ADDENDUM NO. #2

CITY OF PEORIA VILLA LAKE DRIVE & WILDLIFE DRIVE STREET RECONSTRUCTION BID OPENING AT 11AM ON MARCH 22ND, 2022 AND AT PEORIA PUBLIC WORKS

Addendum Issued: MARCH 21, 2022

RE: **Addendum #2** for Villa Lake Drive & Wildlife Drive Street Reconstruction.

TYPICAL SECTIONS

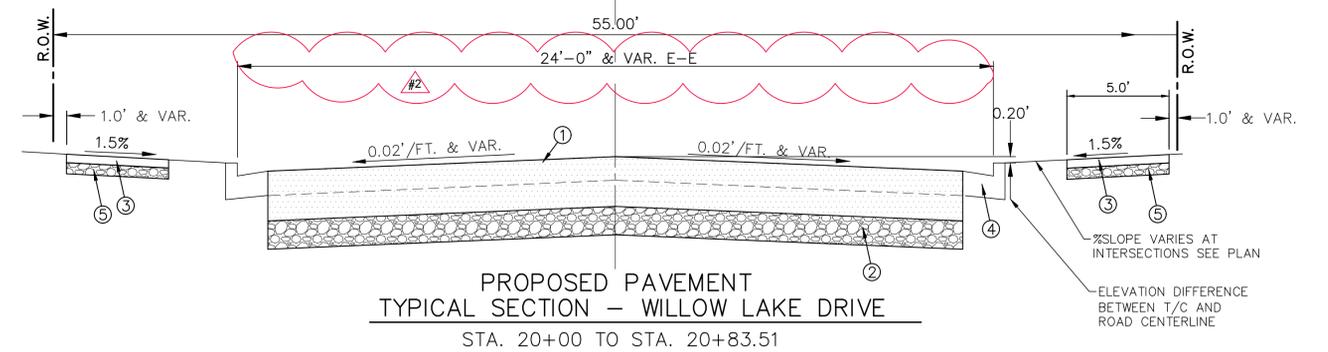
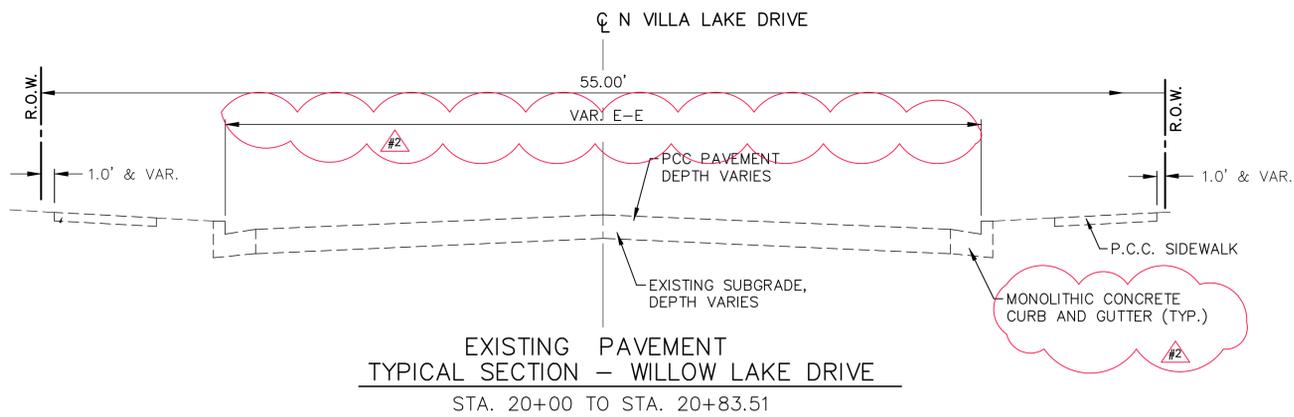
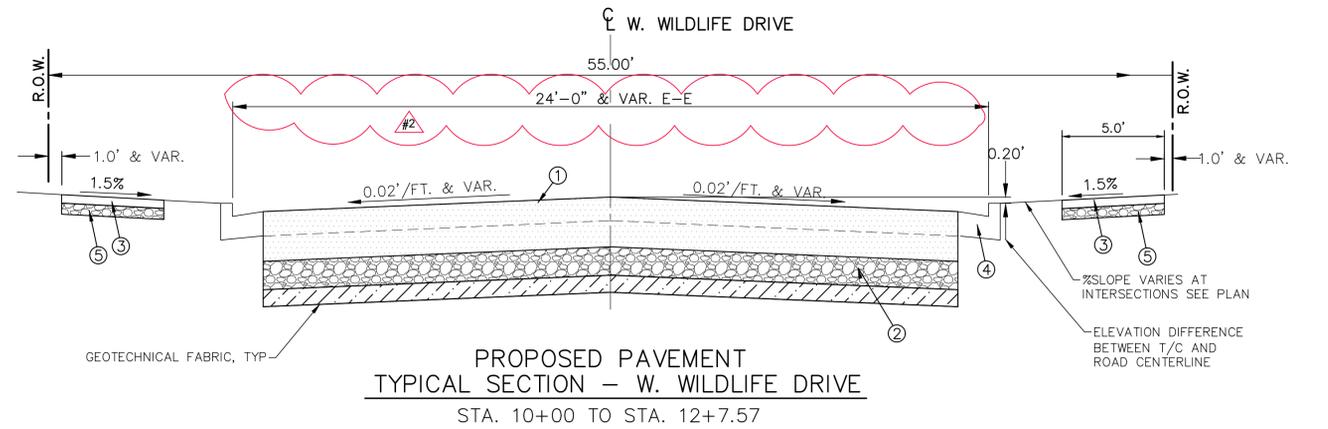
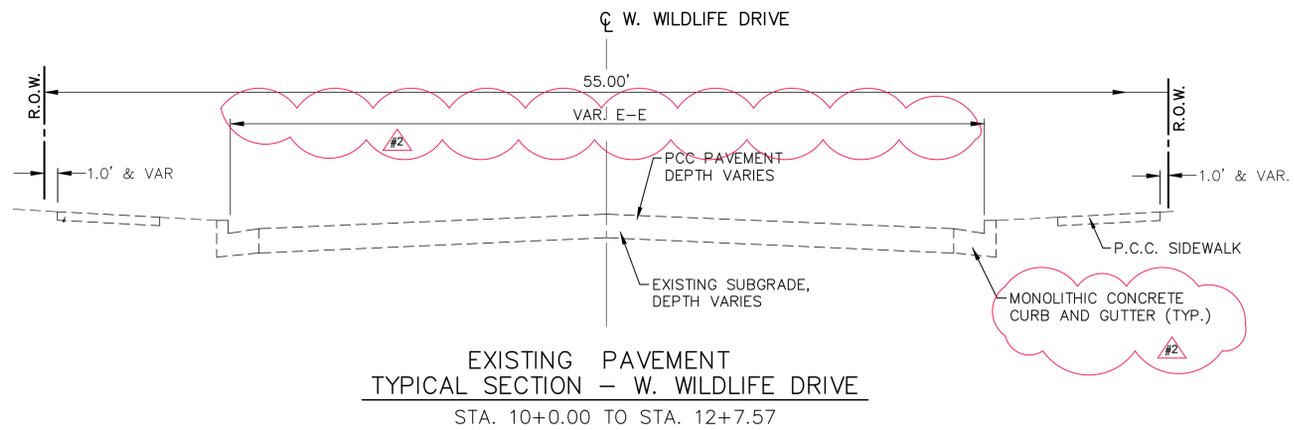
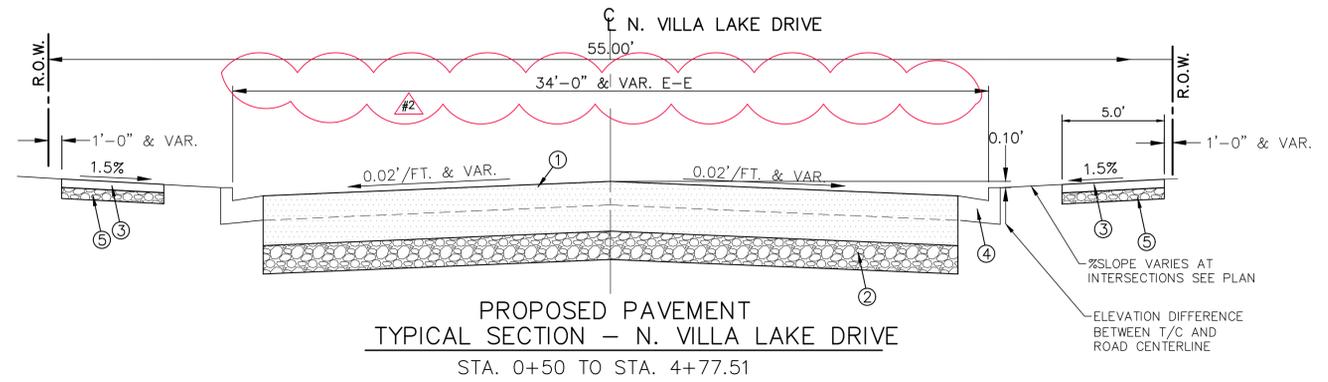
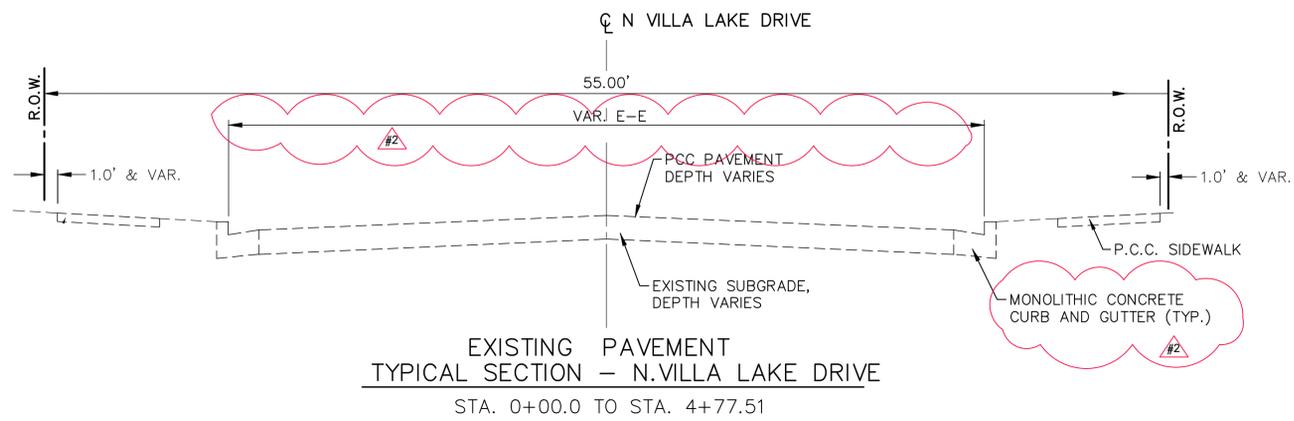
- 1) Plan sheet # 2 OF 14 – QUANTITIES** – Proposed sidewalk quantities were changed to no longer include the stretch of sidewalk connected to the driveway aprons. 42400100 Portland Cement Concrete Sidewalk, 4” was updated from 6,412 SQ.FT. to 5,796 SQ.FT.. The Project total of 42300400 PCC Driveway Pavement 8” changed from 60 SQ.YD. to 128 SQ.YD..
- 2) Plan Sheet # 3 OF 14 – TYPICAL SECTIONS** -Adjusted proposed pavement typical sections width to measure from face of curb to face of curb. Adjusted existing typical sections pavement width to variable. Denoted existing curb as monolithic concrete curb and gutter.

Typical section road widths have been updated, see sheet 3 of 14.
